**Doc 9710, VAP/13**

INTERNATIONAL CIVIL  
AVIATION ORGANIZATION

## **VISUAL AIDS PANEL**

## **REPORT**

Figure 5-18A. Runway turn pad lights (not to scale)

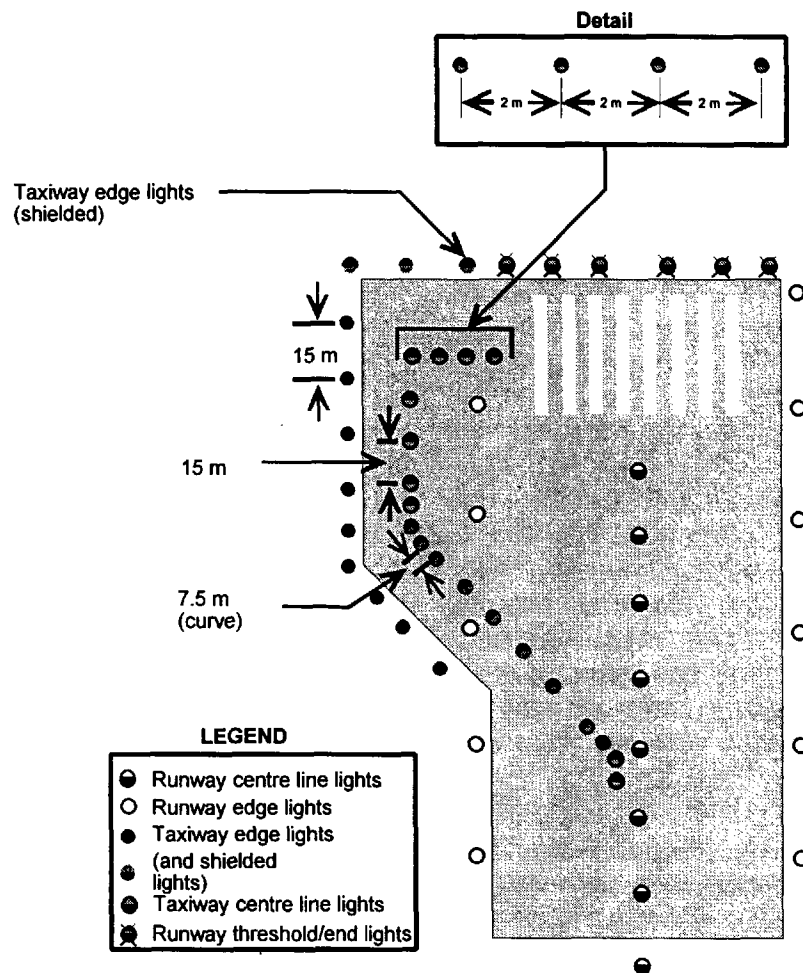
*Insert new figure as follows:*

**5.3.15.6A** Taxiway centre line lights intended to provide guidance through a runway turn pad shall be in accordance with Appendix 2, Figure 2.13, 2.14 or 2.15.

Figure 2.12A. Isocandela diagram for high-intensity taxiway centre line (15 m spacing) and stop bar lights in straight sections intended for use in an advanced surface movement guidance and control system where higher light intensities are required and where large offsets can occur

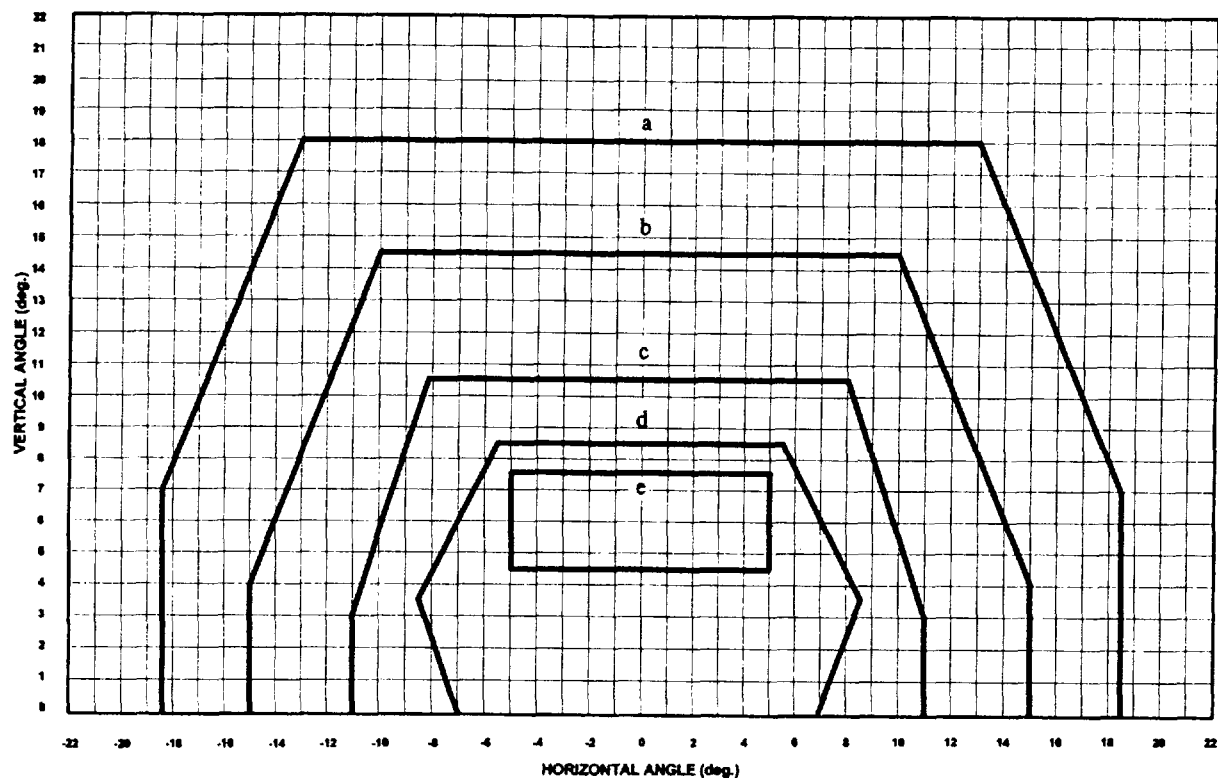
5.3.15.6A Where higher intensities are required for taxiways intended for use in an advanced surface movement guidance and control system, taxiway centre line lights shall be in accordance with the specifications of Appendix 2, Figure 2.12A, 2.12B or 2.12C.

5.3.17.12A Where higher intensities are required for stop bars intended for use in an advanced surface movement guidance and control system, stop bar lights shall be in accordance with the specifications of Appendix 2, Figure 2.12A, 2.12B or 2.12C.

Figure 2.12C. Isocandela diagram for high-intensity taxiway centre line (7.5 m spacing) and stop bar lights in curved sections intended for use in an advanced surface movement guidance and control system where higher light intensities are required

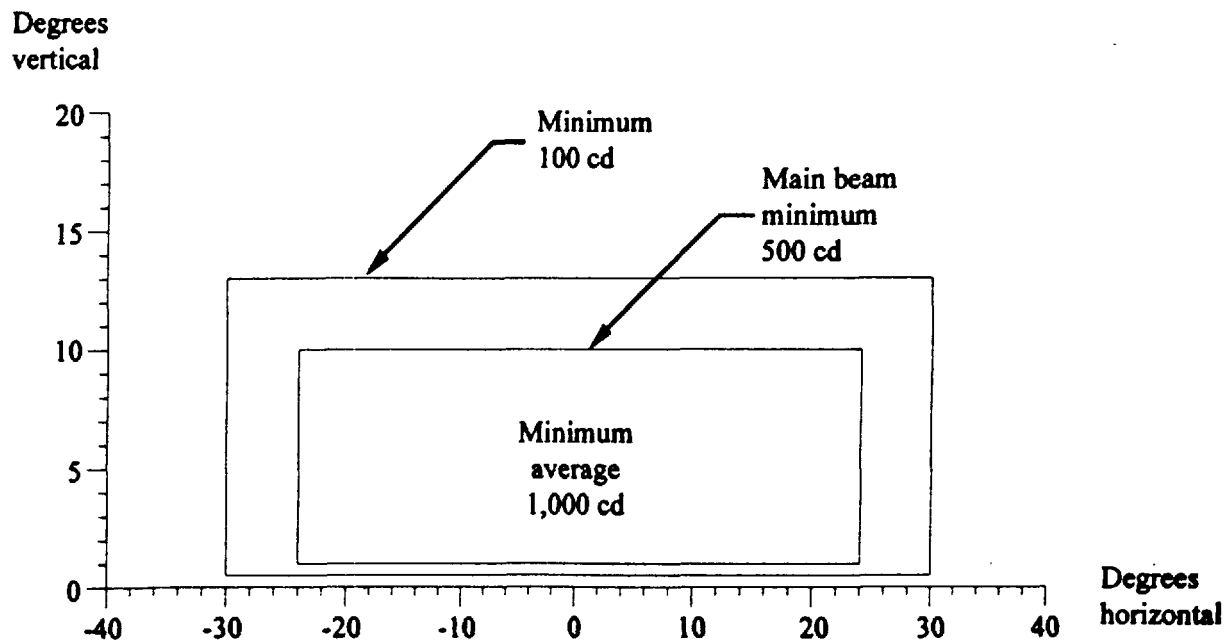
5.3.17.12B Where a wide beam fixture is required, stop bar lights shall be in accordance with the specifications of Appendix 2, Figure 2.12A or 2.12C.

Figure 2.12D Isocandela diagram for high-intensity runway guard lights, Configuration B

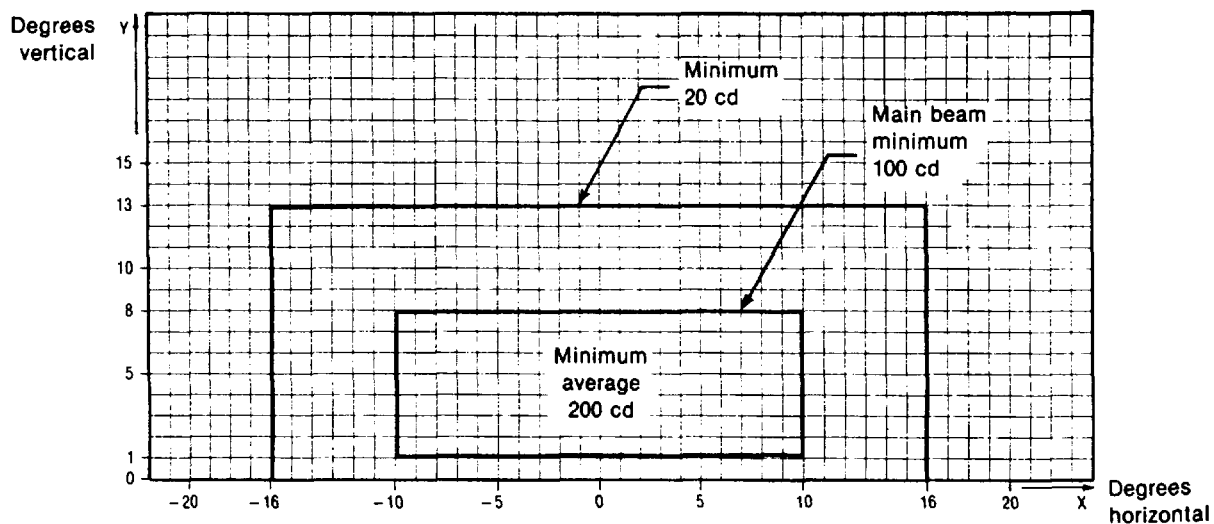
- a) *Appendix 2, Figure 2.12D if the runway guard lights are intended to be used during the day or if they are specified as a component of an advanced surface movement guidance and control system where higher light intensities are required; or*
- b) *Appendix 2, Figure 2.13, if otherwise.*

Figure 5-5A. Rapid exit taxiway indicator marking

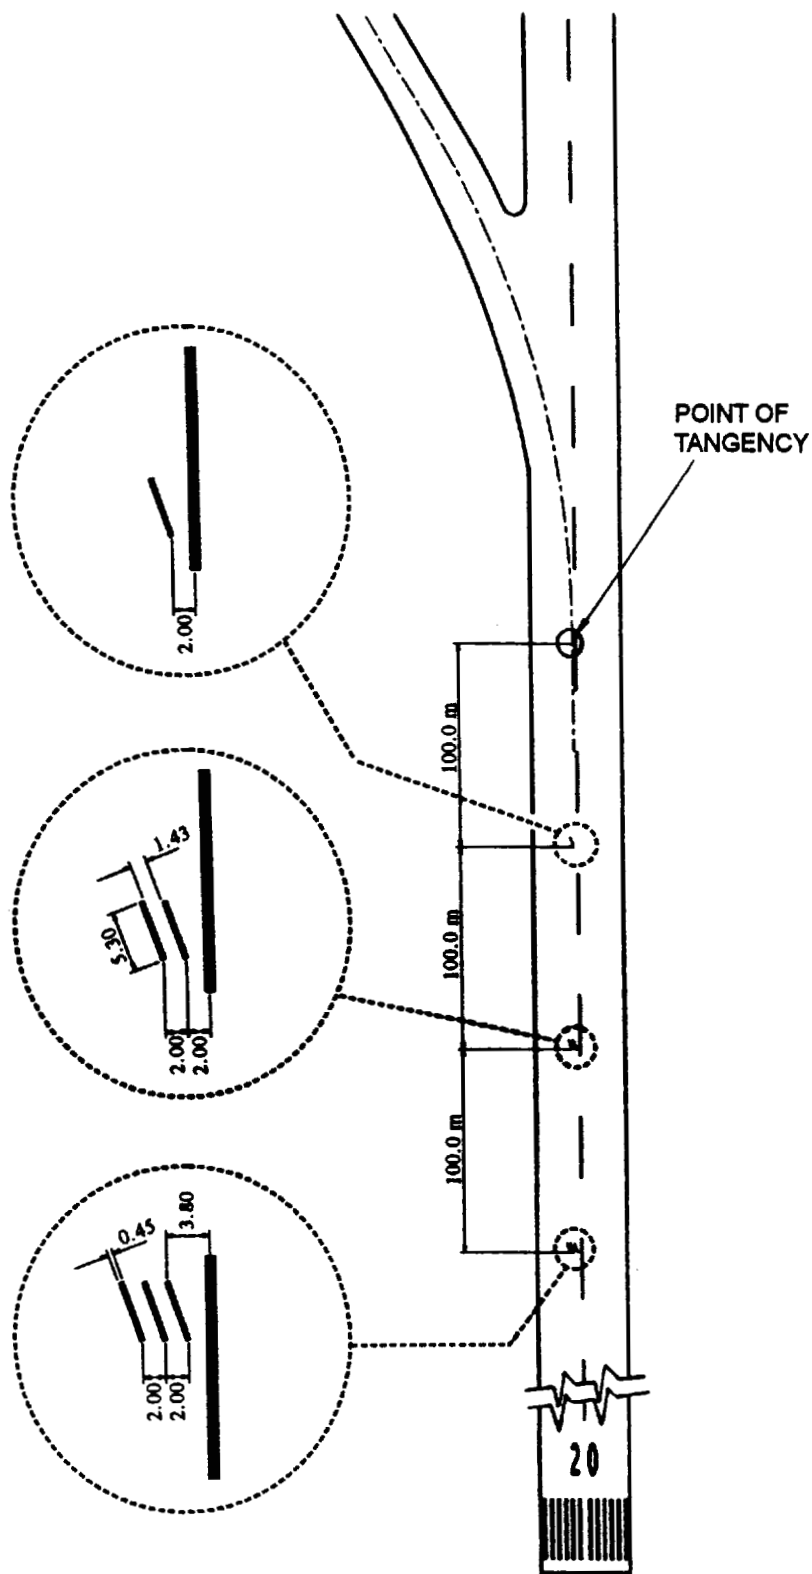
*Insert new figure as follows:*

**5.2.7A.2** Where rapid exit taxiway indicator markings are provided on a runway they shall be located on the same side of the runway centre line as the rapid exit taxiway for which they provide guidance. The rapid exit taxiway indicator markings shall be as shown in Figure 5-5A.

**5.2.7A.3** The rapid exit taxiway indicator markings shall be made up of three sets of markings, as shown in Figure 5-5A. Each marking shall be a single white stripe 5.3 m long and 0.45 m wide. The markings shall be slanted away from the runway centre line such that the nearer end of the nearest stripe is displaced 2.0 m from the runway centre line and the farther end is displaced 3.8 m from the runway centre line. The additional stripes in the first and second sets of markings shall be parallel and spaced at 2 m.

5.3.13A.2 A rapid exit taxiway indicator light shall be located at the approach end of each marking in order to maintain the three, two, one coding as the rapid exit taxiway turn off is approached, as shown in Figure 5-5A.
